HL-4865

Edwin I. Hatch Nuclear Plant
Response to Second Request for Additional Information:
Power Uprate

Edwin I. Hatch Nuclear Plant
Response to Second RFAI
Power Uprate Submittal

Excerpts from NEDC-30997, "Edwin I. Hatch Nuclear Power Plant, Unit 1
Reactor Pressure Vessel Surveillance Materials Testing
and Fracture Toughness Analysis,"
GENE, San Jose, CA, October 1985

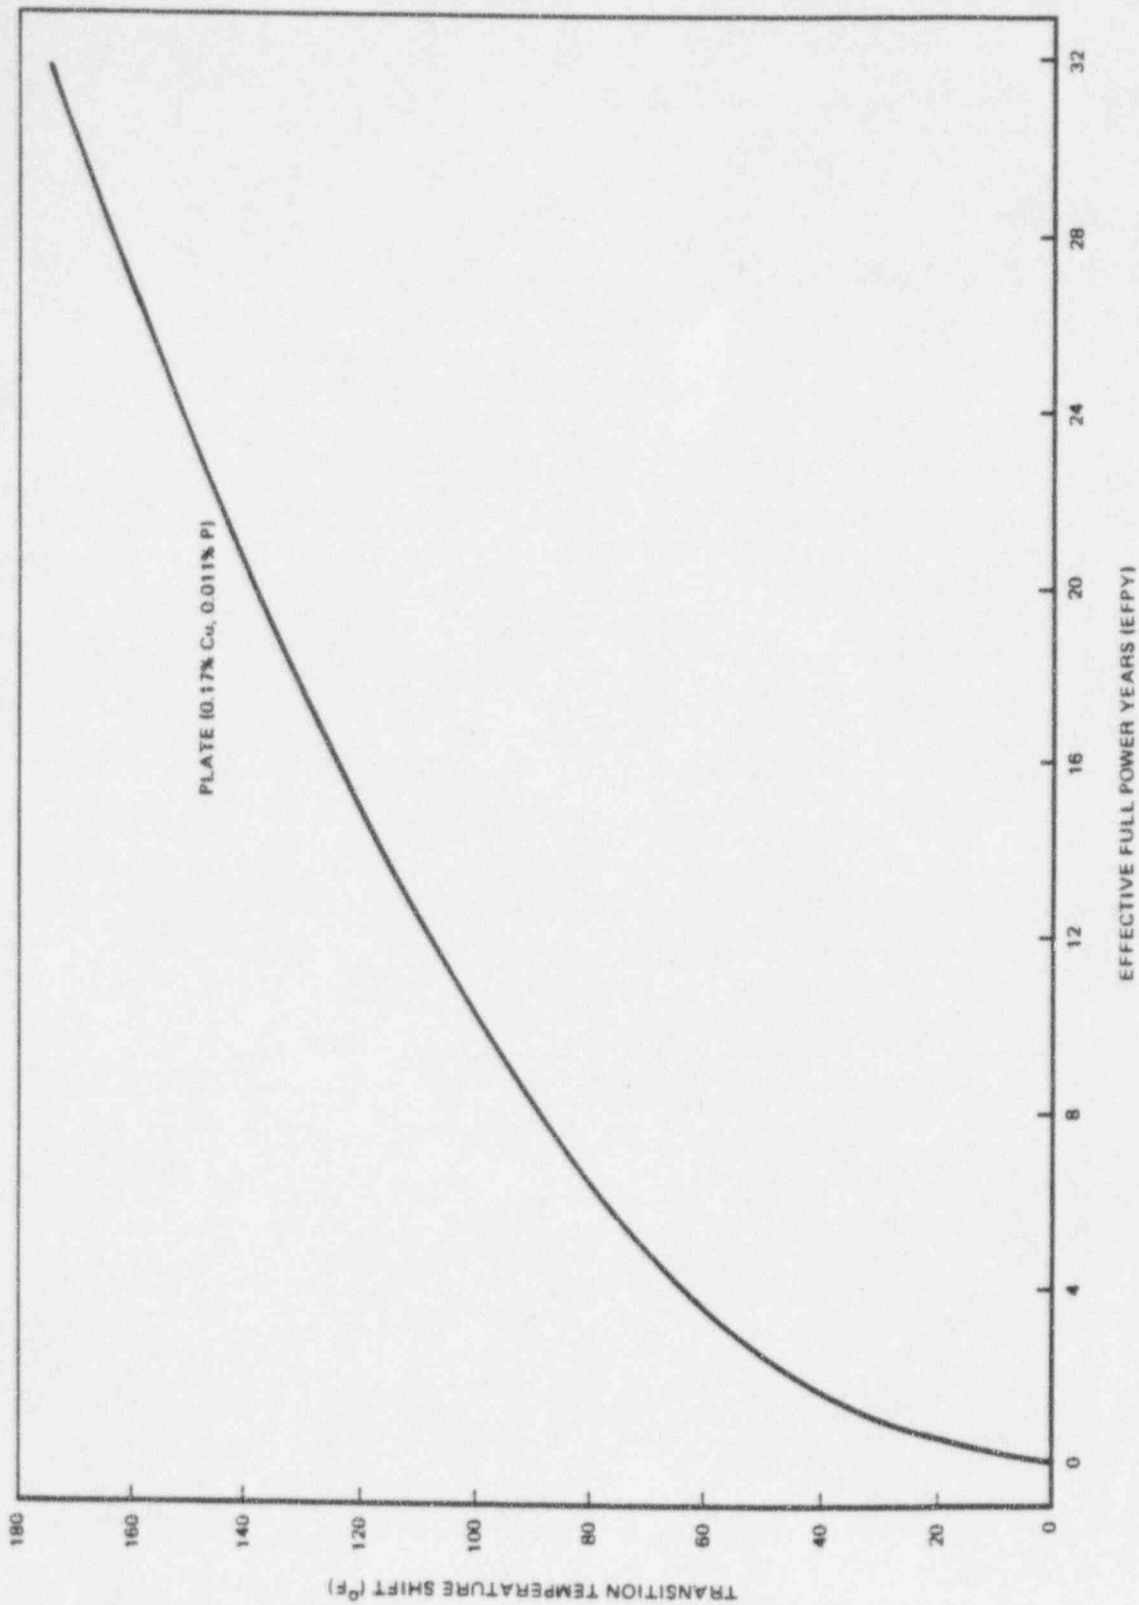
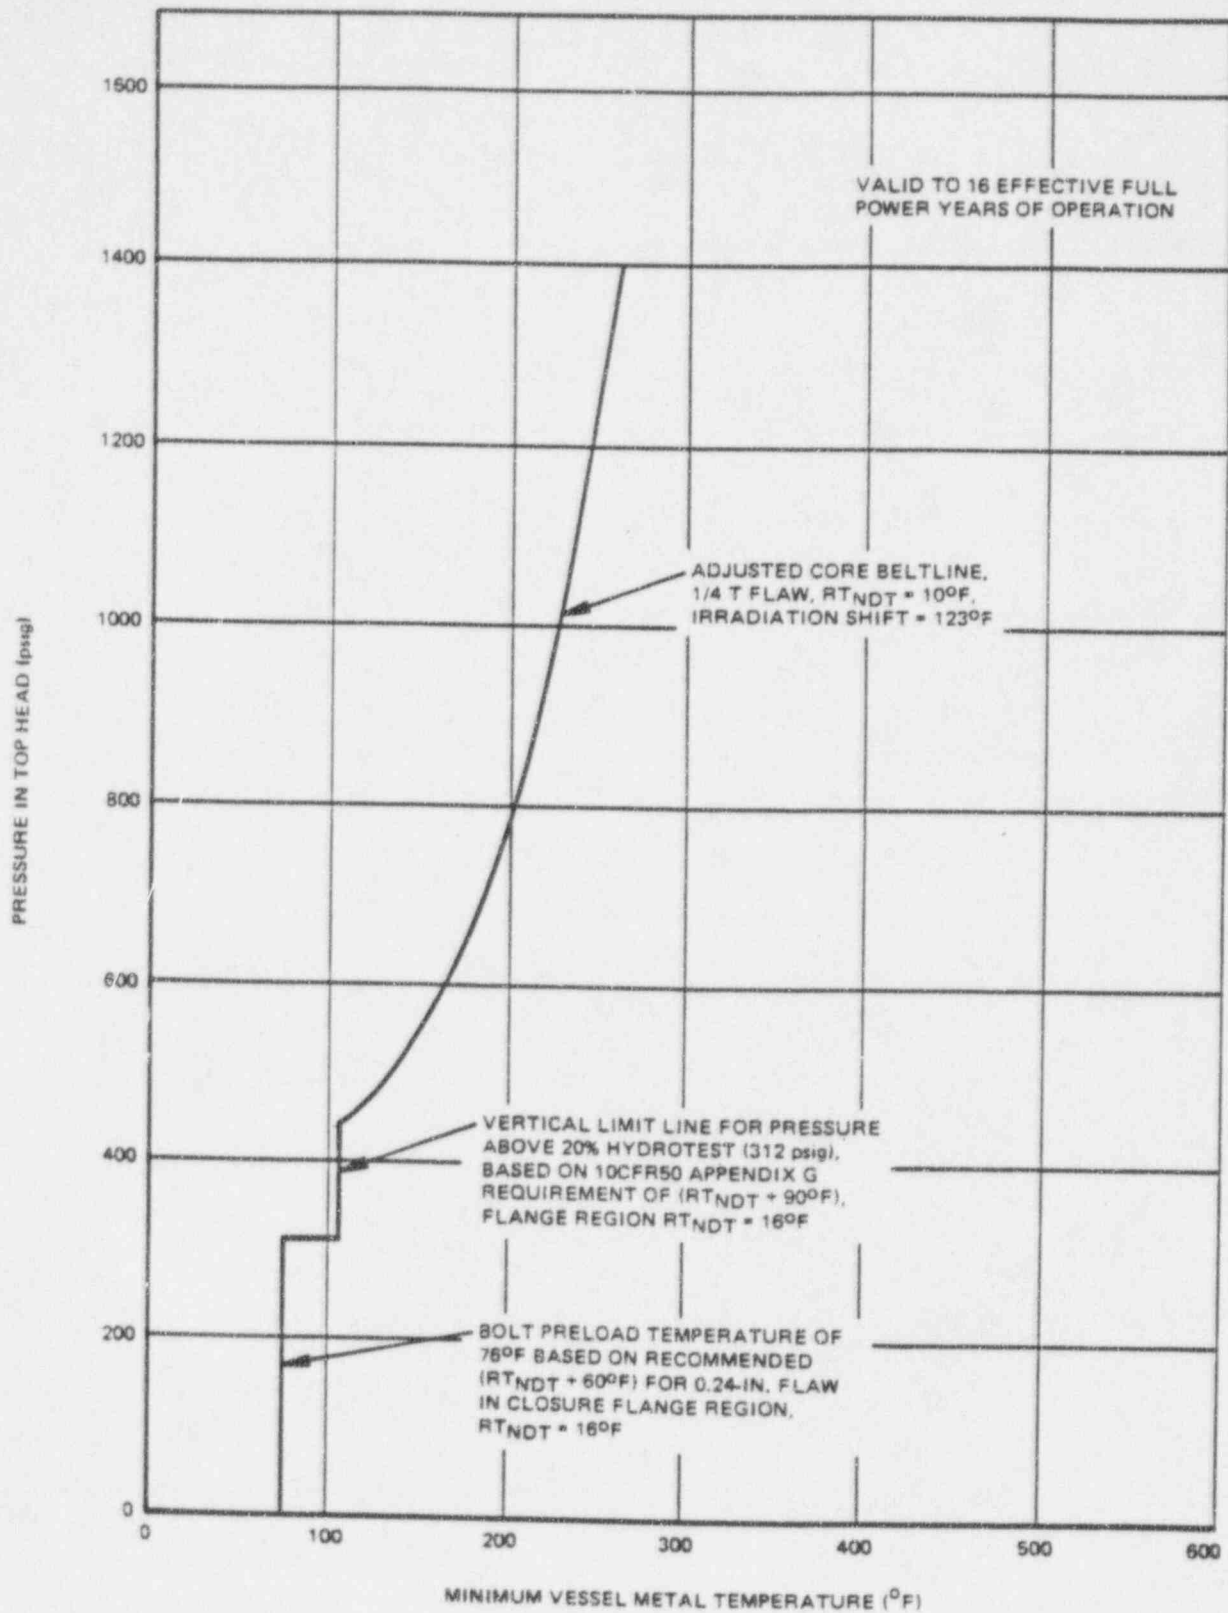
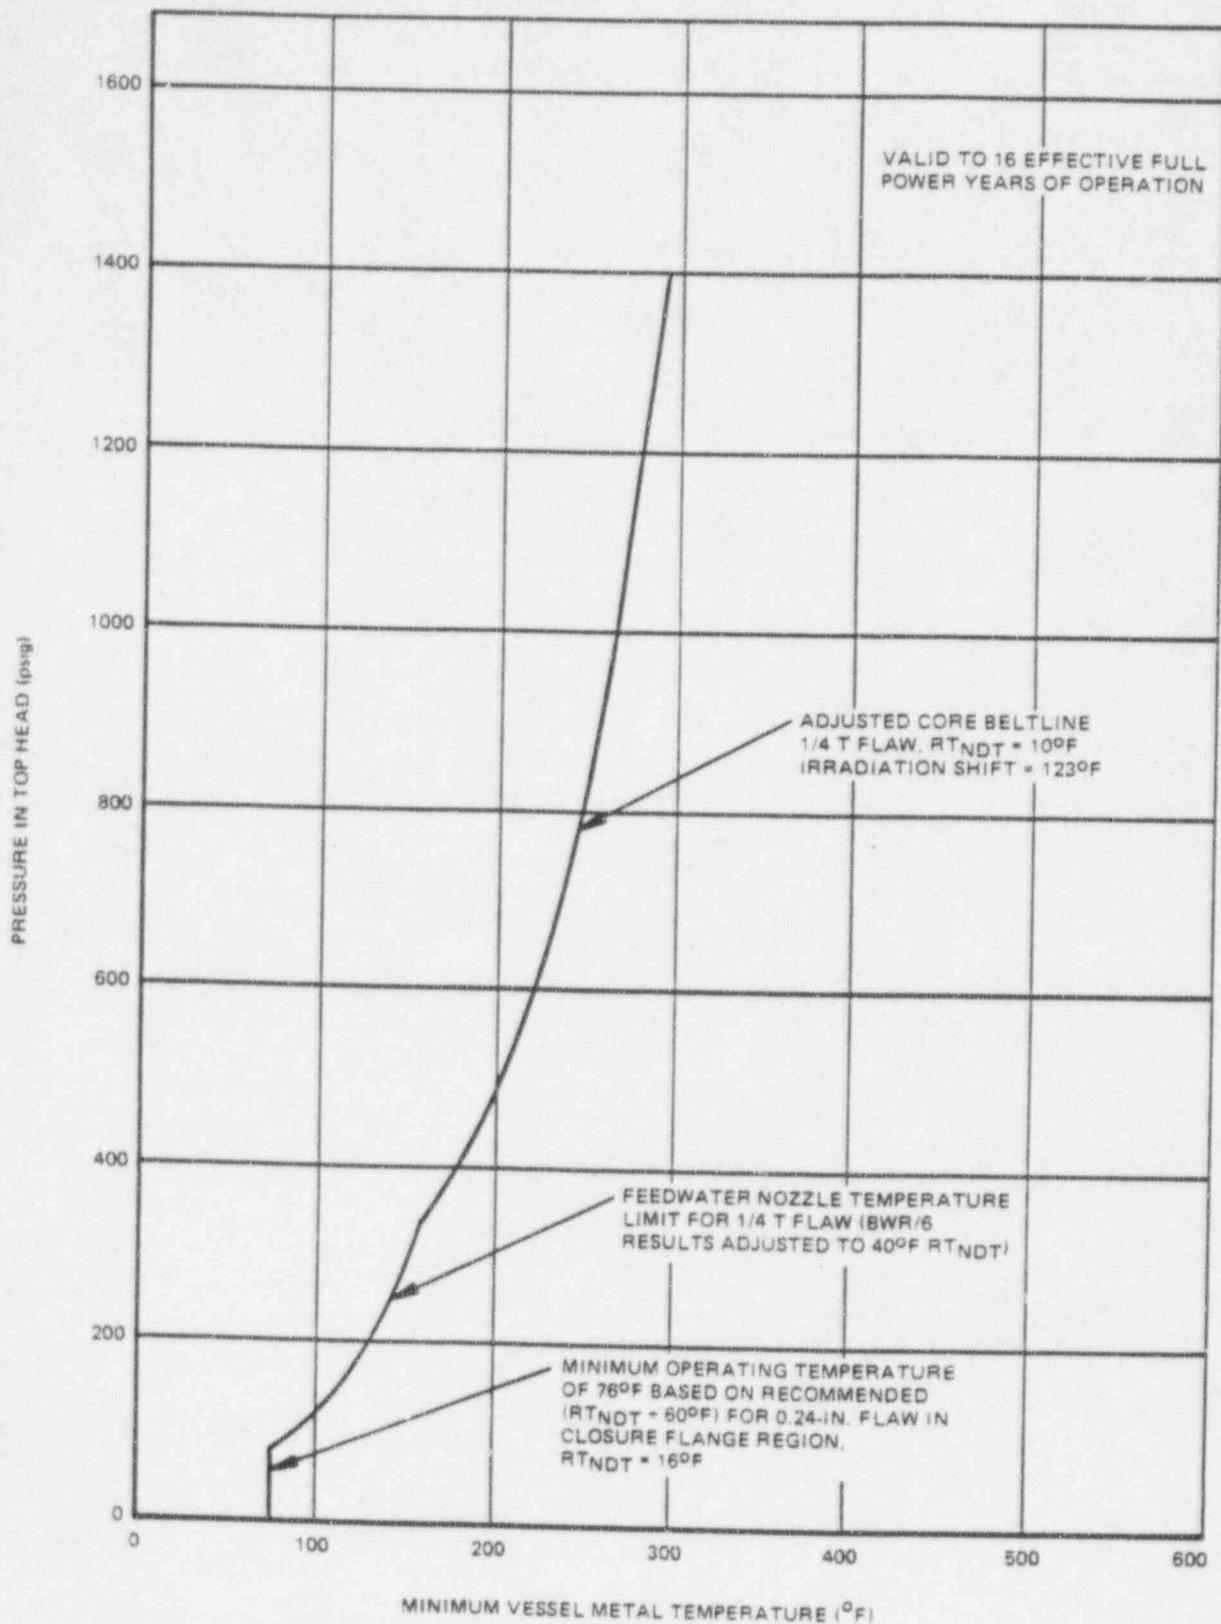
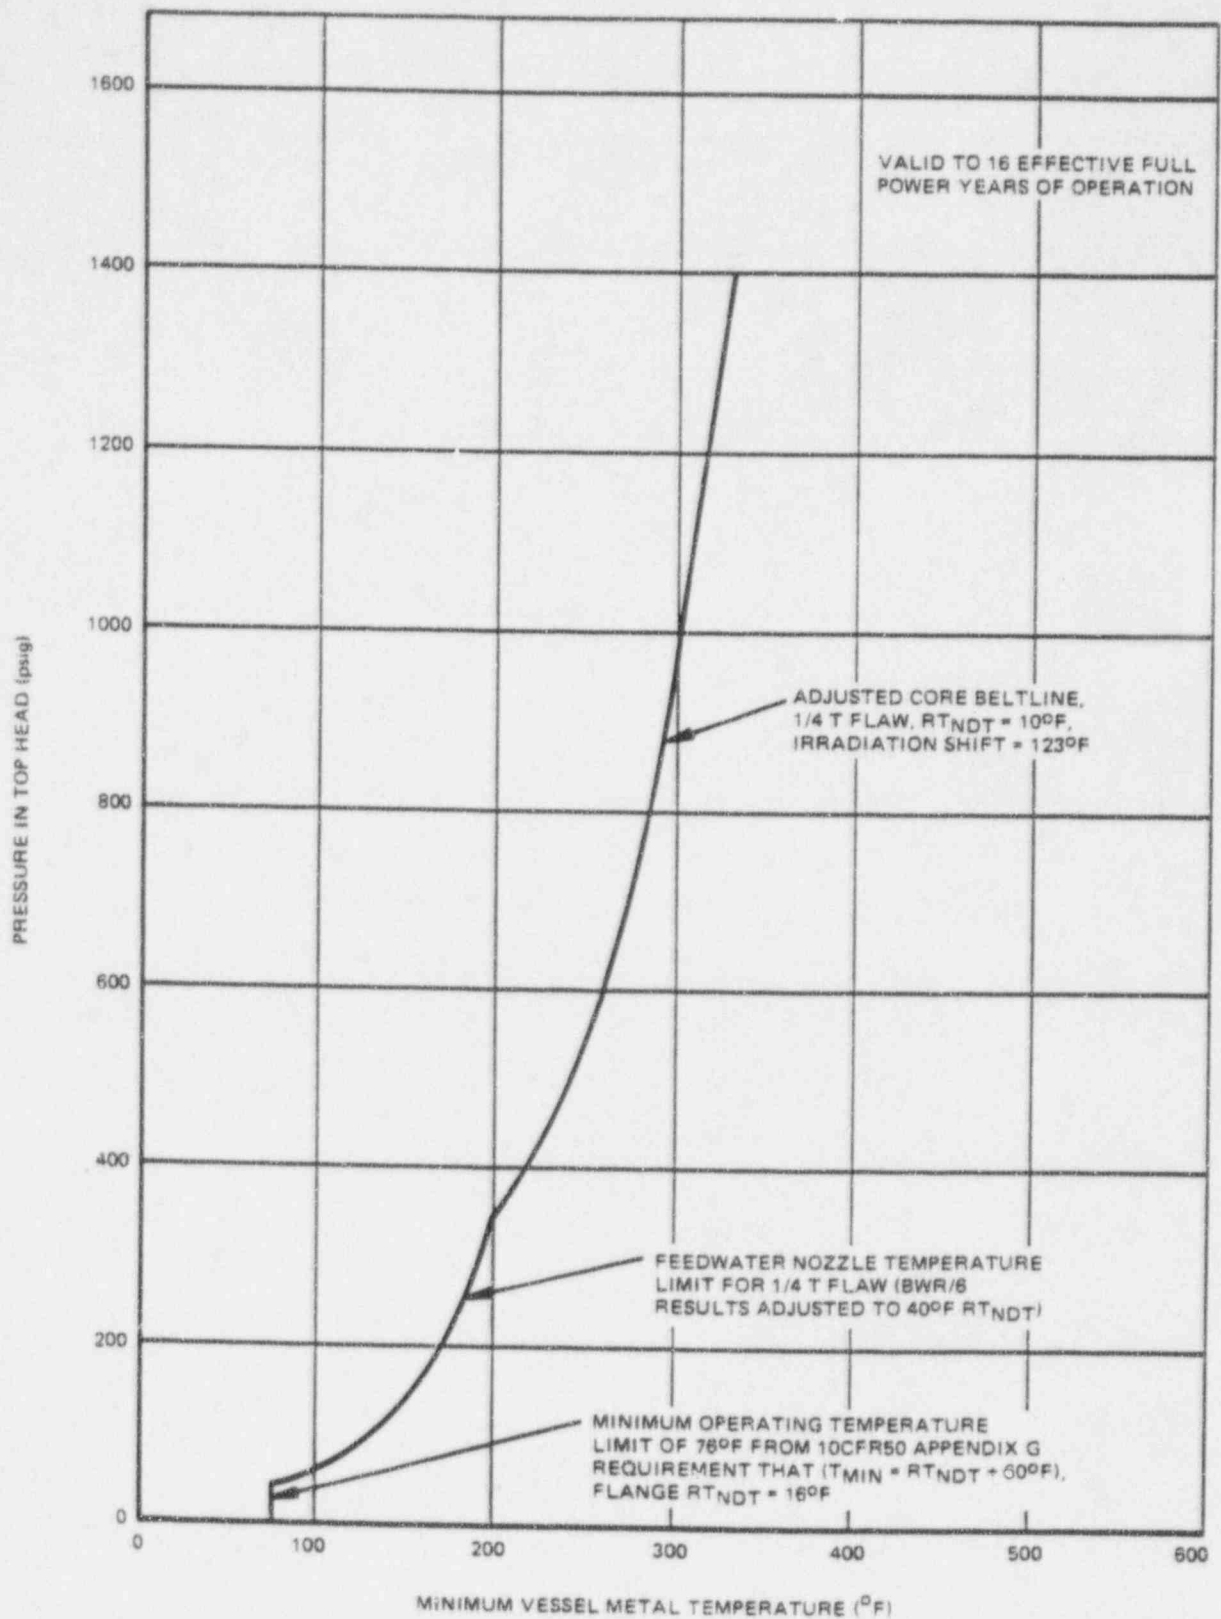
Provide detailed calculations to show how ART of 132° F for the uprate case and 133° F for the current P-T limits were derived for Hatch Unit 1.

17 EFPY ART calculation of 132°F for the uprate case:

ART	= Initial RT _{NDT} + 17 EFPY ΔRT _{NDT} + Margin, where:
Initial RT _{NDT}	= -10°F
17 EFPY ΔRT _{NDT}	= (CF) $f^{(0.28-0.11\log f)}$ = 85.1°F, where:
CF	= 207
$f^{(0.28-0.11\log f)}$	= 0.4113 = Fluence factor. Therefore,
f	= 0.0973
	= 1/4 T fluence at current power for 16 EFPY +
	= 1/4 T fluence at uprated power for 1 EFPY
	= $1.82e18 \text{ n/cm}^2 (16 \text{ yr})/32 \text{ yrs}/1e19 \text{ n/cm}^2 +$
	= $1.82e18 \text{ n/cm}^2 * 1.1 (1 \text{ yr})/32 \text{ yrs}/1e19 \text{ n/cm}^2$
Margin	= 56°F

The 133°F calculations were submitted to the NRC in GPC letter SL-189, dated January 10, 1986. This GPC submittal provided GE Report NEDC-30997, "Edwin I. Hatch Nuclear Power Plant, Unit 1, Reactor Pressure Vessel Surveillance Materials Testing and Fracture Toughness Analysis," October 1985. The NRC reviewed this report and approved the Unit 1 P-T curves as Amendment 126 to the Unit 1 Technical Specifications. Pertinent pages of NEDC-30997 are provided in Attachment A to this enclosure.
